SUBJECT: NuScale Power, LLC Response to NRC Request for Additional Information No. 137 (eRAI No. 8973) on the NuScale Design Certification Application

RAIO-0218-58804

Response to Request for Additional Information Docket No. 52-048

eRAI No.: 8973

Figure 1: Stiffener Wall and Adjacent Structures

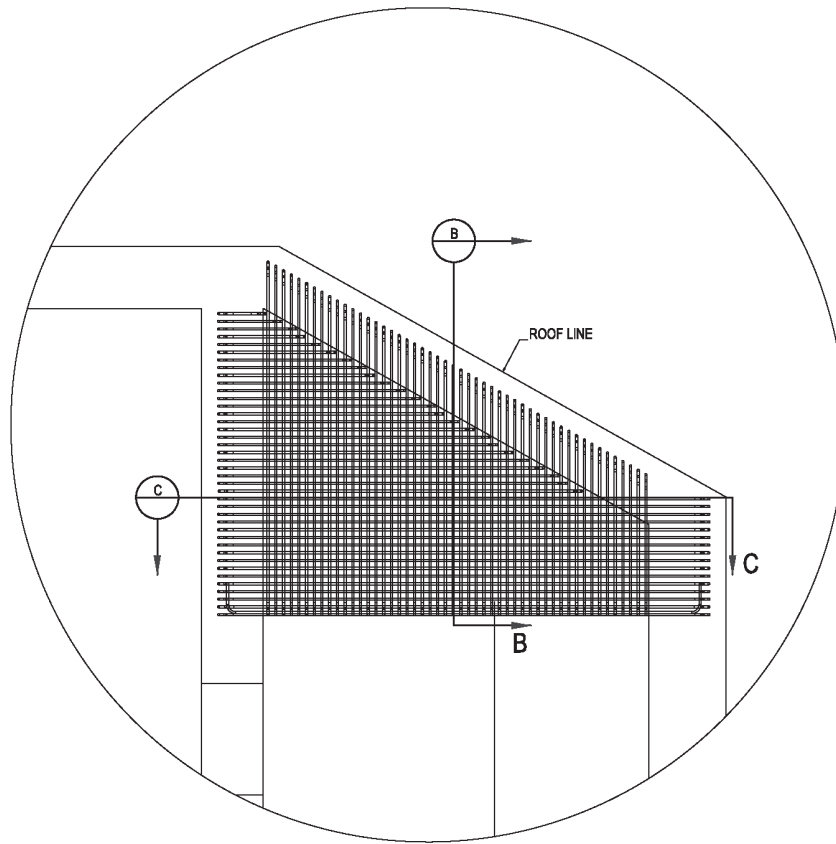
Figures 1.2-18, 3.8.4-5, 3B-11, 3B-13, 3B-15 (same as 3B-43), 3B-17, 3B-19, 3B-20, show stiffener walls (as described in Appendix 3B) immediately below the sloping portion of the roof and coinciding with the pilaster locations in the east-west direction. Describe the load path from the stiffener walls to the basemat of the reactor building. Augment the details of reinforcement layout figures provided in Appendix B to clearly show the connection between the structural members upon which these stiffener walls are supported and their connection to the roof (e.g. section views also showing the roof reinforcement).

As shown in Figure 1, the stiffener walls connect the two parallel walls in the East-West direction on both sides of the RXB building with the sloped portion of the roof.

Figure 2: Stiffener Wall Horizontal Reinforcement Anchorage into Adjacent Walls

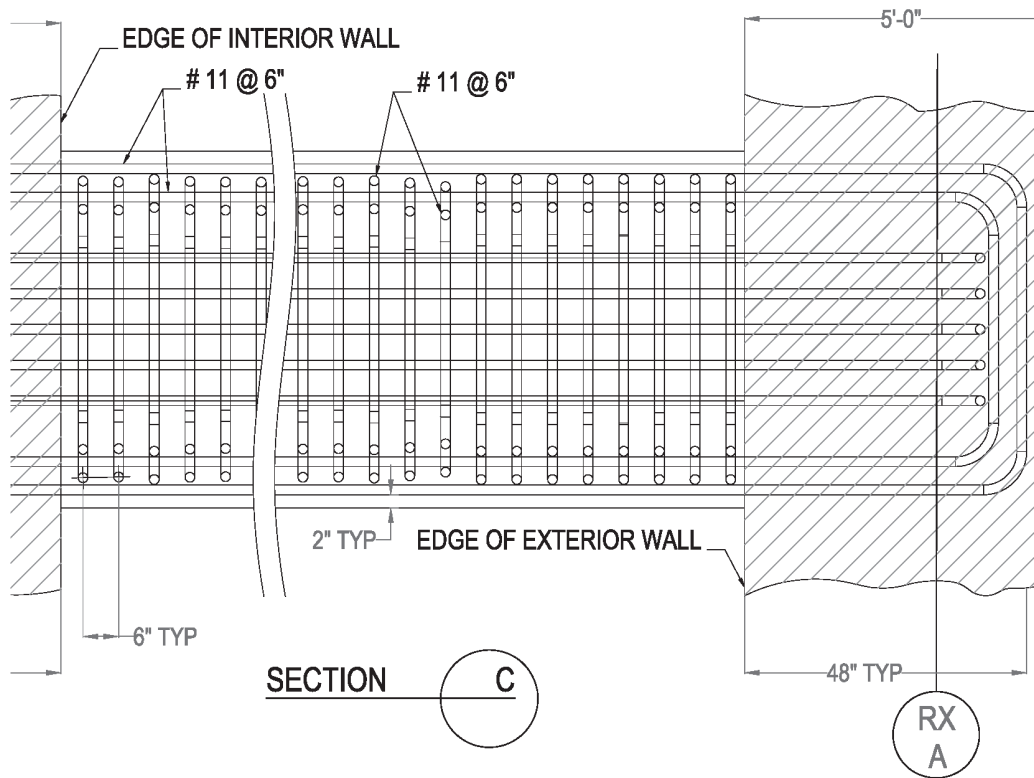
Describe how the horizontal components of the inclined seismic forces from the sloping roof plates, are resisted.

Figure 2 and Figure 3 show how the horizontal and vertical stiffener wall reinforcement are anchored into the two adjacent walls and the roof slab, respectively.

The horizontal components of the inclined seismic forces from the sloping roof plates are resisted by out-of-plane shear and bending of the walls. The stiffener walls connect the two walls to act together and transfer the forces to the East-West direction walls. The forces in the walls are transferred to the basemat through the slabs and shear walls along grid lines RX1 and RX7.

Figure 1: Reactor Building Top and Bottom Roof Rebar Arrangement (not to scale)

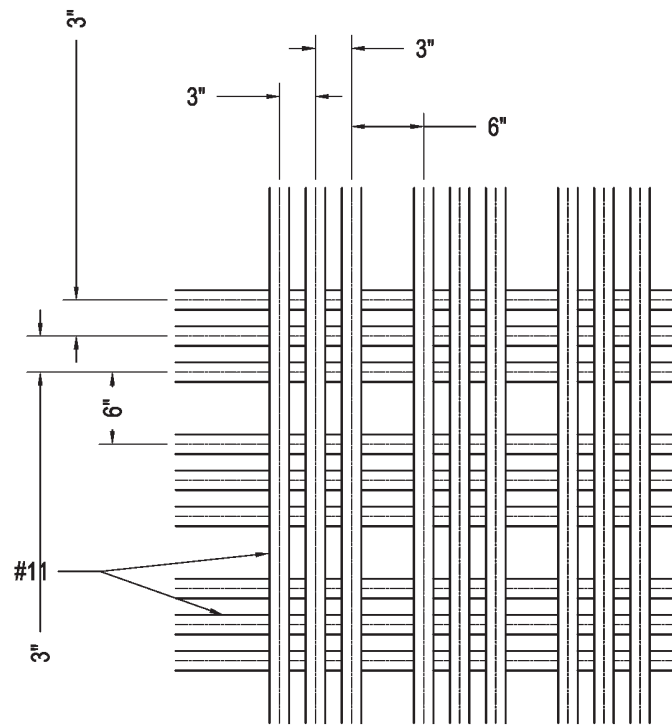
Figure 3B-30 shows a reinforcement section view (North-South view) for the RXB roof slab. Augment the details provided in this figure to explicitly identify the rebar for the sloping portion of the roof and the rebar for the supporting walls shown in this section view, rebar development length, and concrete clear cover information. Provide an east-west section view with reinforcement details for the roof.

The roof reinforcement consists of two layers of rebar spaced at 3"-3"-6"-3"-3"-6" pattern in both directions at the top and the bottom of roof slab as shown in Figure 1.

The bottom reinforcements of the sloped portion of the roof are anchored into the outside wall along RX-A and RX-E by 90 degree and 180 degree hooks extended into the wall and fully developed per ACI 349-06 requirements. On the other side, the bottom reinforcement is anchored into the wall along RX-A.7 and RX-D.3 and the flat portion of the roof as shown in Figure 3B-30.

Figure 3B-47: RXB Reinforcement Section View of RXB Wall at Grid Line B

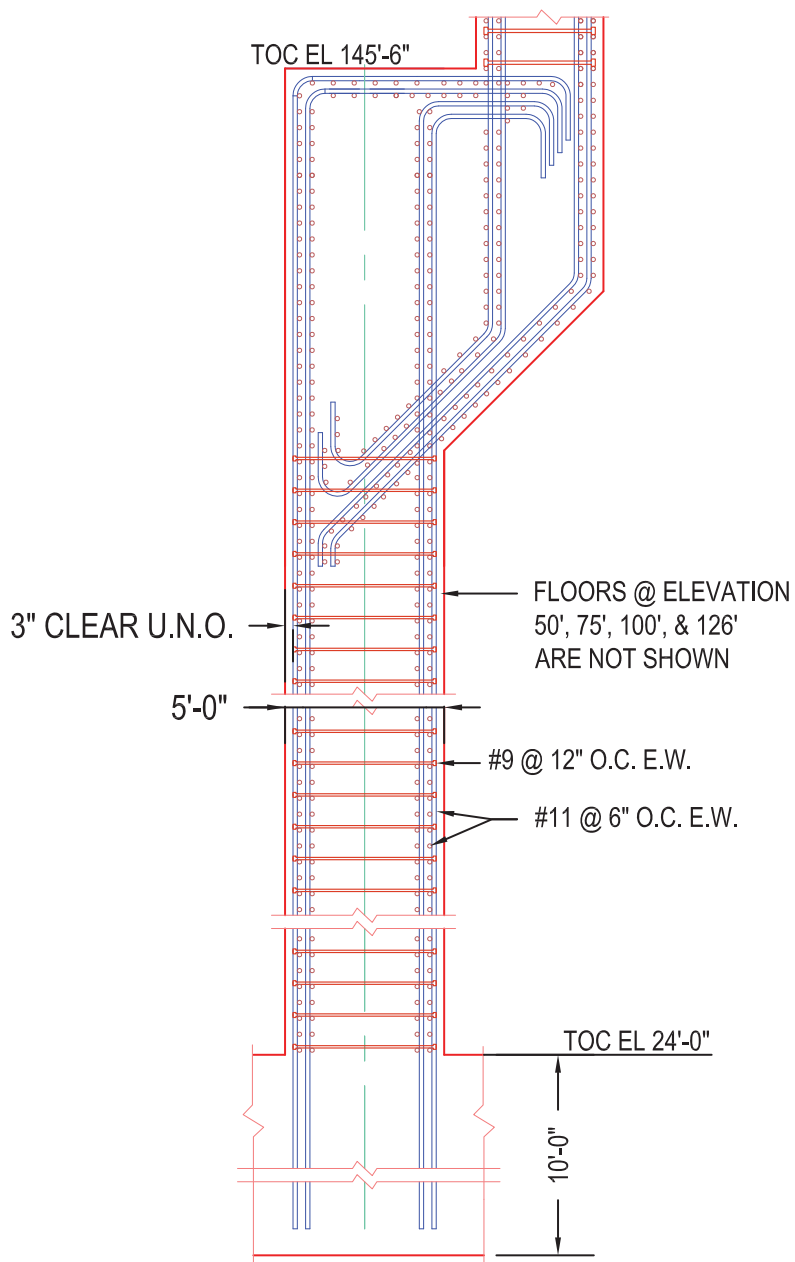
3B-24; and others); provide development length and concrete clear cover distances in the current reinforcement drawings in FSAR, Tier 2, Appendix 3B. Further, clarify whether the drawing in Figure 3B-47 applies to the section cut identified in Figure 3B-46. If not, provide the applicable drawing.

Further, section views provided in FSAR Tier 2, Appendix 3B are revised to include and correct section cut IDs. For instance, Figure 3B-47 applies to the section cut identified in Figure 3B-46. The figures showing reinforcement drawings are also revised to provide the development length and concrete clear cover distances. The revised figures include 3B-8, 3B-9, 3B-11 through 3B-13, 3B-15 through 3B-17, 3B-19 through 3B-21, 3B-23, 3B-24, 3B-26, 3B-27, 3B-29, 3B-30, 3B-38, 3B-39, 3B-43, 3B-44, 3B-46, 3B-47, 3B-51, and 3B-52. Detailed design information regarding wall reinforcement is removed from Appendix 3B.2.2, 3B.3.3, 3B.3.4, 3B.3.5, and Tables 3B-2, 3B-3, 3B-7, 3B-8, 3B-10, 3B-11, 3B-13 through 3B-15, 3B-17 through 3B-23, 3B-25, 3B-28, 3B-29, 3B-31, 3B-32, 3B-42, 3B-46, 3B-48, and 3B-49.
